# SERVICE No. 246 BULLETIN

Piper Aircraft Corporation

Subject: Modification of Oxygen Cylinder Rear Retaining Strap  
Piper Part Number 758 109

Models Affected: PA-30 Twin Comanches (NOTE: Applicable only to  
aircraft that have had an oxygen system installed at  
the factory or aircraft that have had Piper Oxygen  
Installation Kit 757 100 installed.)

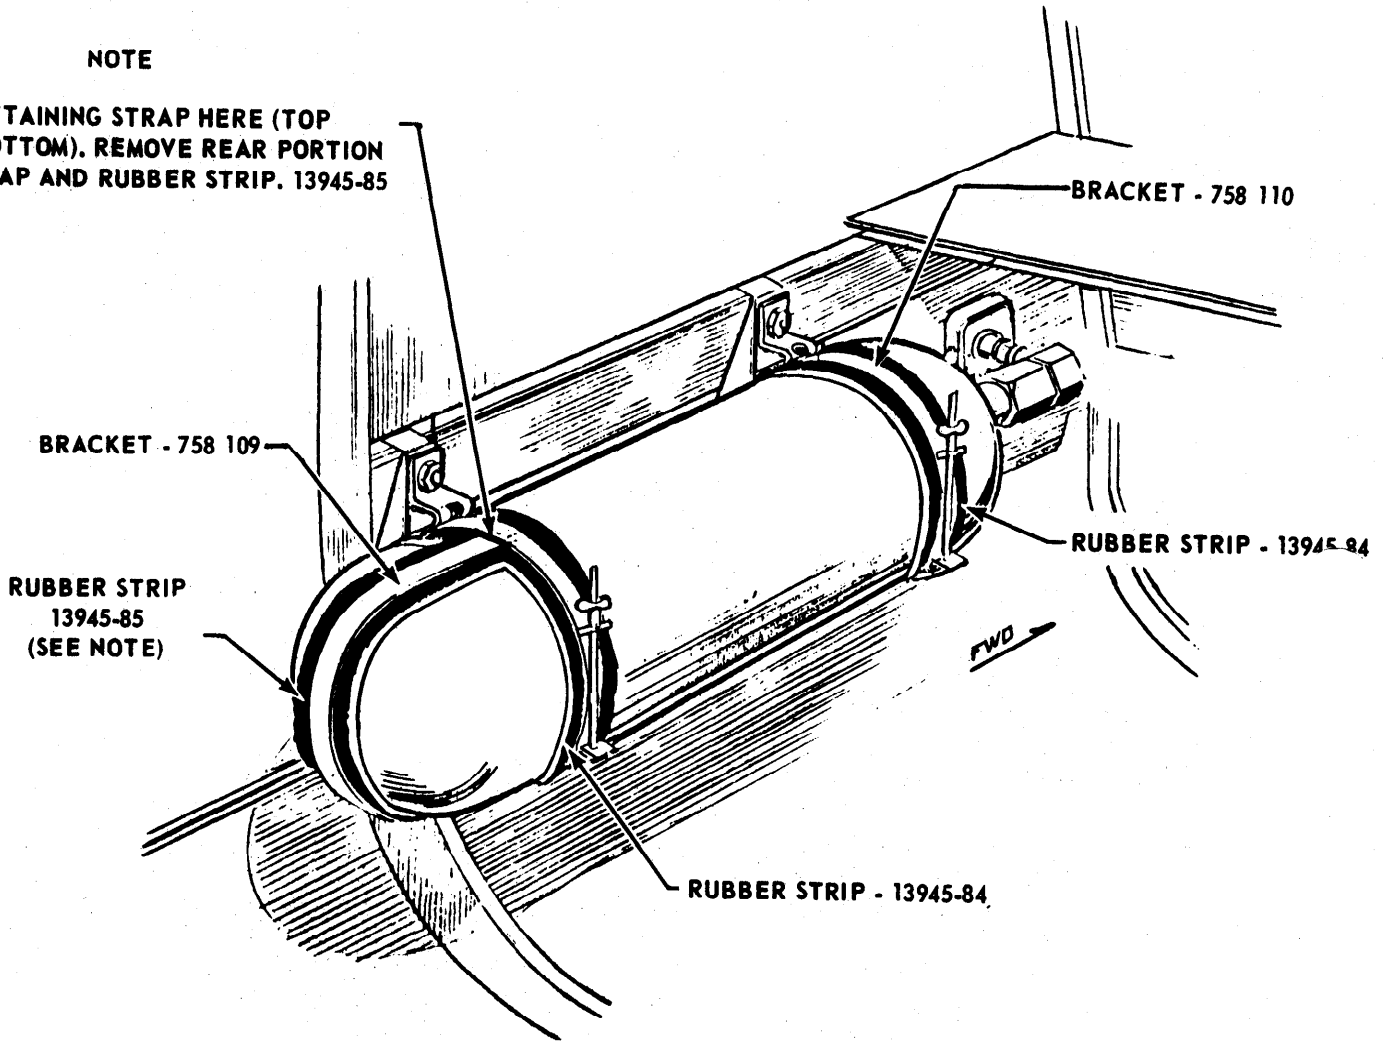
Reason For Bulletin: Modification of the oxygen cylinder rear retaining strap  
part number 758 109 to preclude the possibility of the  
strap rubbing the rudder control cable.

Modification Instructions: See sketch on reverse side of this bulletin.

**CUT RETAINING STRAP HERE (TOP AND BOTTOM). REMOVE REAR PORTION OF STRAP AND RUBBER STRIP. 13945-85**
